# TECHNICAL SERVICE BULLETIN

ITEM T81/01

SUBJECT: AXLE SHAFT CIRCLIP GROOVE

MODELS: TR7; TR8

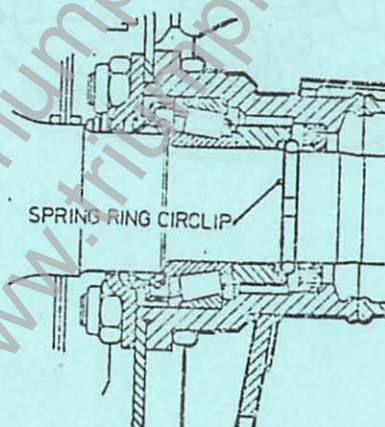
New axle halfshafts incorporating a circlip groove have been introduced from VIN 204451.

Bearing and seal kit, GHK 1019, can only be used on axle shafts without the circlip groove. Bearing and seal kit, GHK 1028 may be used with both types of halfshafts.

In the event that a halfshaft assembly is to be replaced on vehicles prior to the above VIN the modified parts should be fitted.
